# PLANNING & ZONING COMMISSION

**CASE NO:** PZ 1180-2022

**REQUEST:** Hold a Public Hearing and forward a recommendation to City Council on the request of Jason Hawksworth of Hawk-Attollo LLC, on behalf of Petersen Health System Inc, to obtain a Special Use in a Class R-3 (Single-Family Residential) District for a Solar Utility Facility for the property located at 3901 W Reservoir Blvd (Parcel Identification No. 13-25-177-002), Peoria IL (Council District 4)

Sheet Number:  
**P1.0**

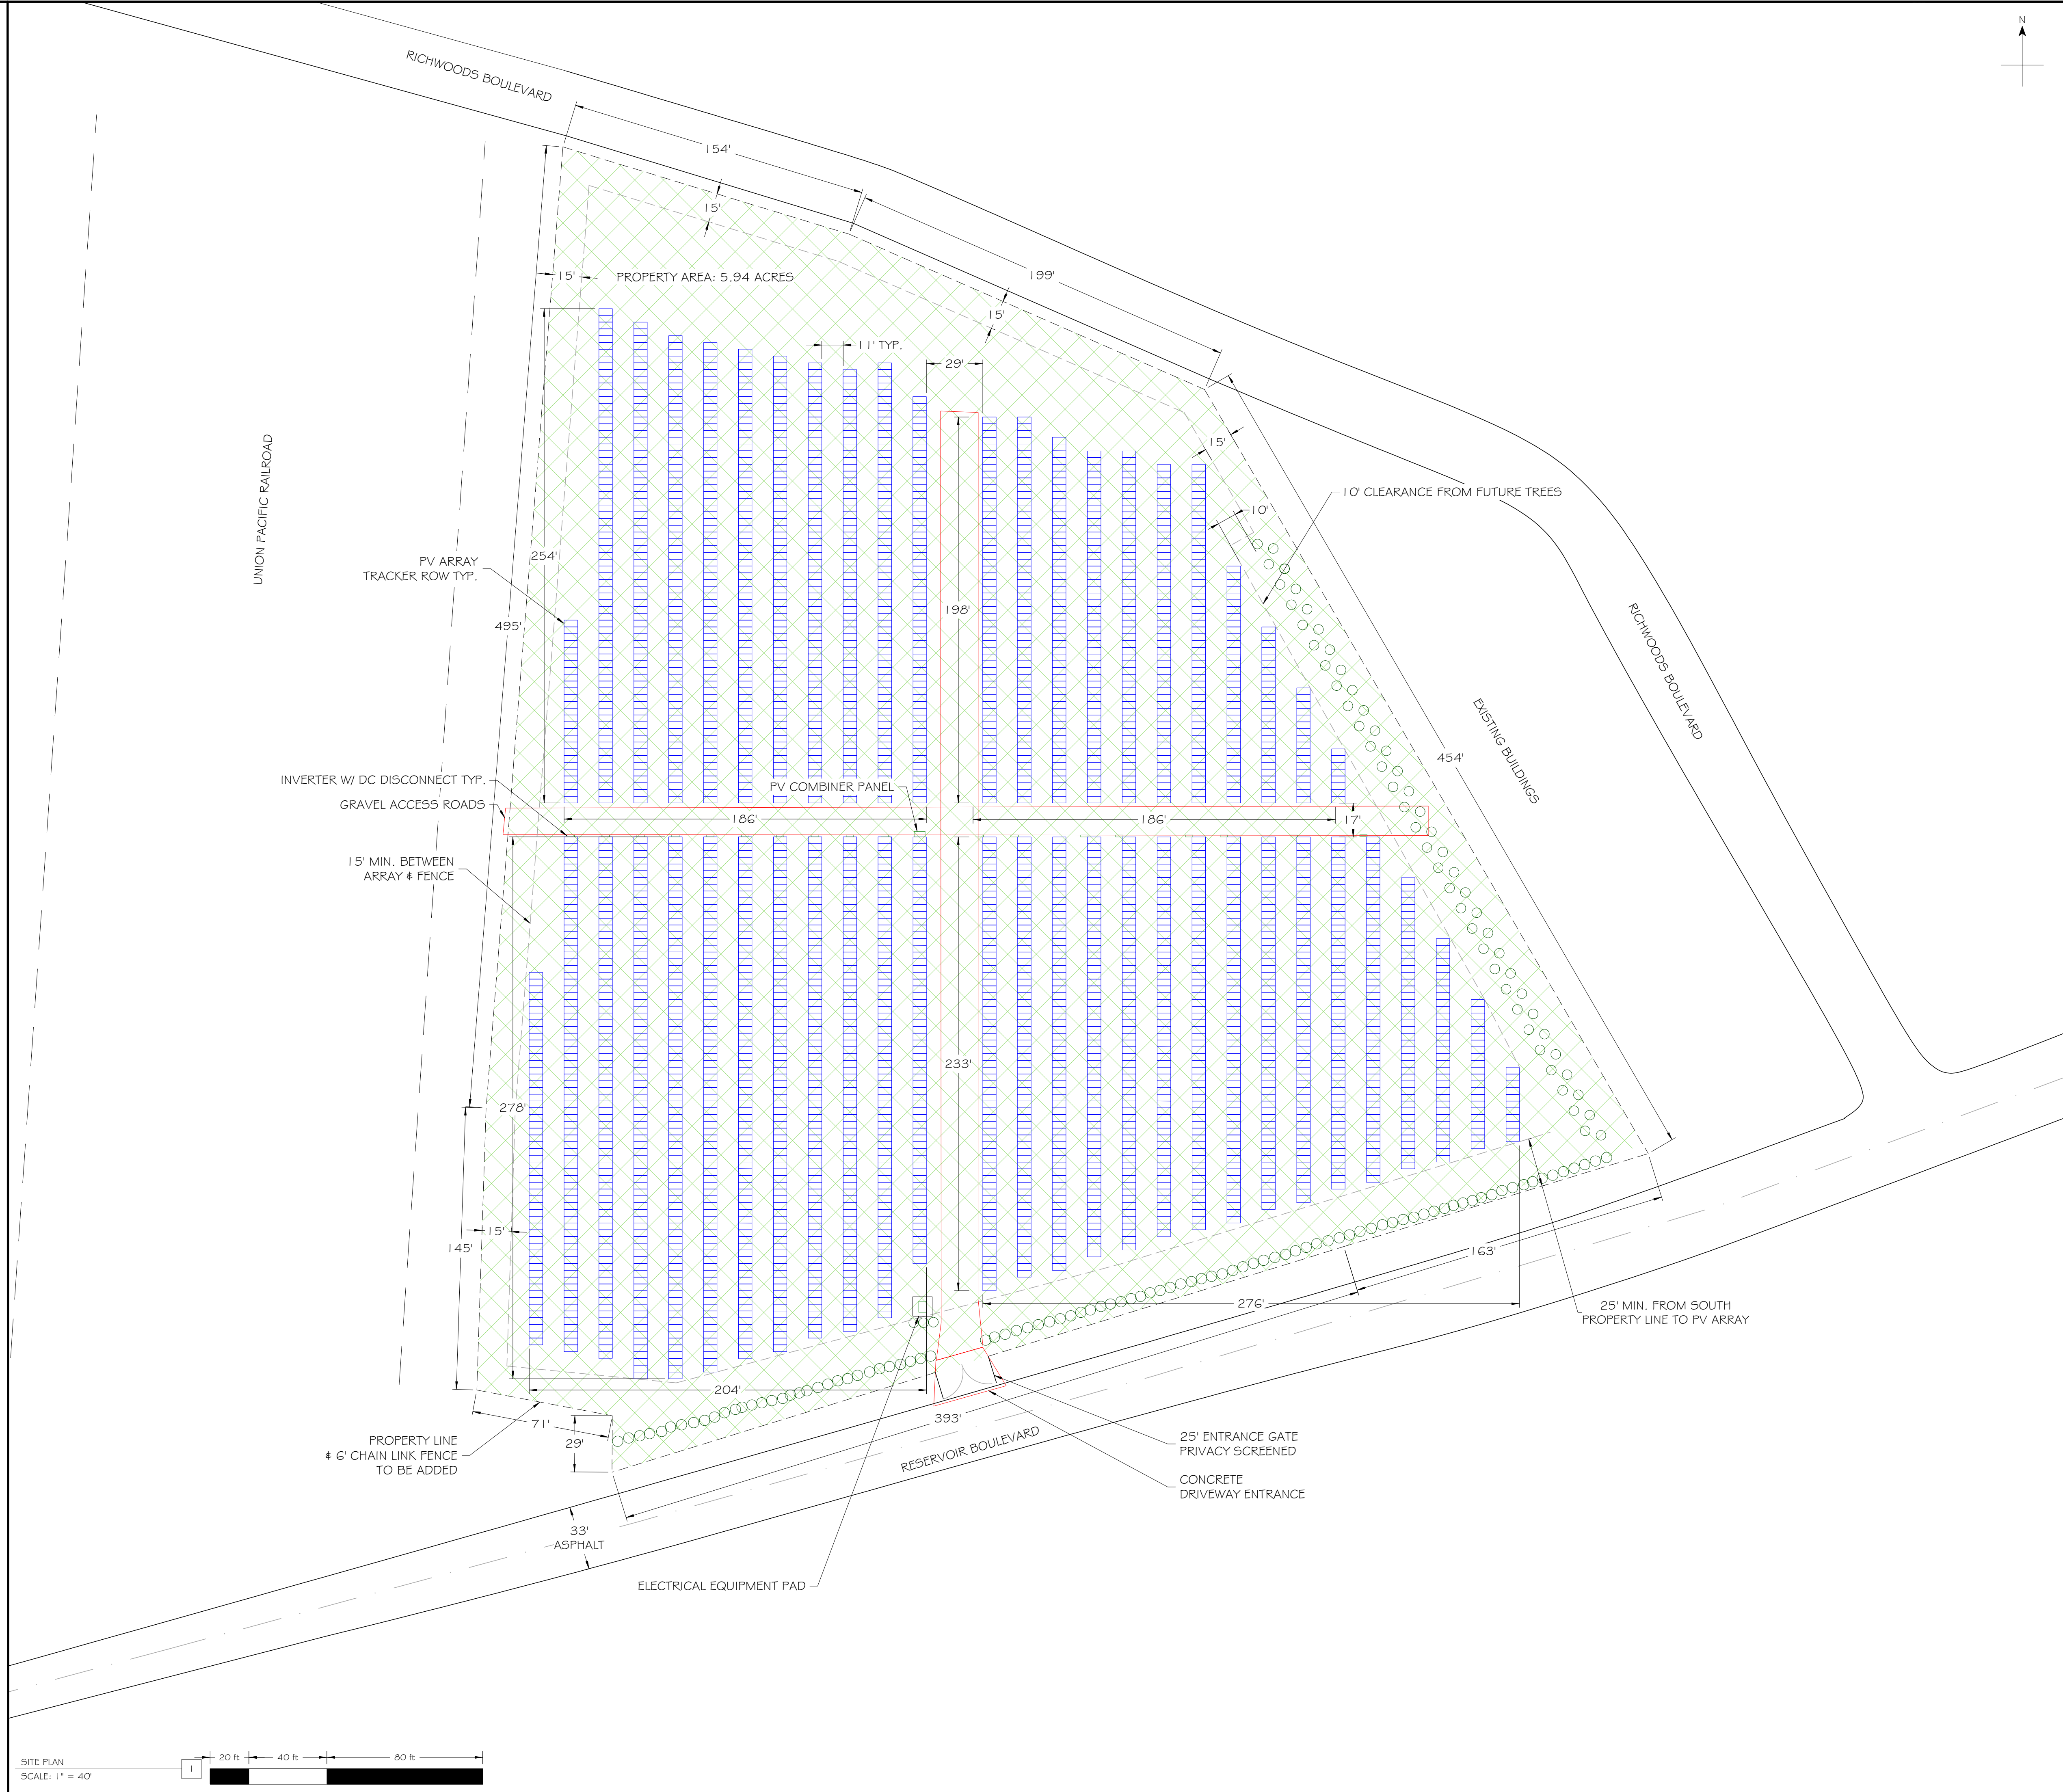
Development Item	Applicant Proposal	Applicant Waiver Request & Justification	DRB Comment
Entrance/ Sidewalk	<p>Proposed 15ft wide entrance gate on W Reservoir Blvd.</p> <p>A north-south gravel access road and an east-west gravel access road provides internal access to the facility.</p>	<p>Waiver to eliminate required sidewalk along frontages on W Reservoir Blvd and W Richwoods Blvd.</p>	<p>Condition to install required 5ft wide sidewalk along the frontages on W Reservoir Blvd and W Richwoods Blvd.</p> <p>Condition for all vehicular access driveways and roads be constructed with hard, dustless surfaces or permeable pavers/porous paving systems.</p>
Mechanical & Utility Screening	<p>Proposed electrical equipment pad located near the facility entrance.</p>	<p>None</p>	<p>Condition for equipment facilities and accessory buildings to be designed with brick, stone, and/or block material.</p>
Landscaping	<p>Front yard along W Reservoir Blvd = approx. 93 shrubs to avoid shading of the solar array.</p> <p>Front yard along W Richwoods Blvd to preserve existing trees/wooded area.</p>	<p>Waiver to plant shrubs in place of trees along the front yard of W Reservoir Blvd.</p>	<p>Condition to meet the required front yard landscaping along W Reservoir Blvd of 278 points utilizing plants from the tree classification.</p> <p>Condition to provide a revised landscape plan indicating the area along the front yard of W Richwoods Blvd to remain undisturbed for preservation of existing trees/wooded area.</p>

Development Item	Applicant Proposal	Applicant Waiver Request & Justification	DRB Comment
Buffers & Screening	Proposed transitional buffer yard (TBY) is 25 feet in depth along the eastern property line abutting the Valley View residential development. Approx 57 evergreen trees = 855 points.	None	In compliance.
Signs	No proposed signage.	None	A separate sign permit is required for any signage.
Fence/Walls	Proposed 6ft tall chain link fence placed on the property line for the entirety of the parcel perimeter.	Waiver to allow chain link material and increase the height of the fence from 3 ft to 6ft in the front yards along W Richwoods Blvd and W Reservoir Blvd.	Condition to revise the fence material along the frontage of W Reservoir Blvd to masonry, wood, aluminum or wrought iron to meet the requirement of compatibility with existing character of the site and neighborhood.  Condition to revise the fence along the eastern property line to be a solid fence to provide screening for the Valley View residential development.

Standard	Standard Met per DRB Review	DRB Condition Request & Justification
No detriment to public health, safety, or general welfare	Yes	None
No injury to other property nor diminishment to property values	Yes	None
No impediment to orderly development	Yes	None
Provides adequate facilities	Yes	None
Ingress/Egress measures designed to minimize traffic congestion	Yes	None
If a public use/service, then a public benefit	N/A	N/A
Conforms to all district regulations	No	<p>Waiver to place a 6ft tall chain link fence in the front yard along W Richwoods Blvd</p> <p>Conditions to:</p> <ul style="list-style-type: none"> <li>• Install required 5ft wide sidewalk along the frontages on W Reservoir Blvd and W Richwoods Blvd.</li> <li>• All vehicular access driveways and roads be constructed with hard, dustless surfaces or permeable pavers/porous paving systems.</li> <li>• Equipment facilities and accessory buildings to be designed with brick, stone, and/or block material.</li> <li>• Meet the required front yard landscaping along W Reservoir Blvd of 278 points utilizing plants from the tree classification.</li> <li>• Provide a revised landscape plan indicating the area along the front yard of W Richwoods Blvd to remain undisturbed for preservation of existing trees/wooded area.</li> <li>• Revise the fence material along the frontage of W Reservoir Blvd to masonry, wood, aluminum or wrought iron to be compatible with existing character of the site and neighborhood.</li> <li>• Revise the fence along the eastern property line to be a solid fence to provide screening for the Valley View residential development.</li> </ul>

1. Waiver to place a 6ft tall chain link fence in the front yard along W Richwoods Blvd
2. Condition to install required 5ft wide sidewalk along the frontages on W Reservoir Blvd and W Richwoods Blvd.

3. Condition for all vehicular access driveways and roads be constructed with hard, dustless surfaces or permeable pavers/porous paving systems.
4. Condition for equipment facilities and accessory buildings to be designed with brick, stone, and/or block material.

5. Condition to meet the required front yard landscaping along W Reservoir Blvd of 278 points utilizing plants from the tree classification.
6. Condition to provide a revised landscape plan indicating the area along the front yard of W Richwoods Blvd to remain undisturbed for preservation of existing trees/wooded area.

7. Condition to revise to the fence material along the frontage of W Reservoir Blvd to masonry, wood, aluminum or wrought iron to be compatible with existing character of the site and neighborhood.

8. Condition to revise the fence along the eastern property line to be a solid fence to provide screening for the Valley View residential development.
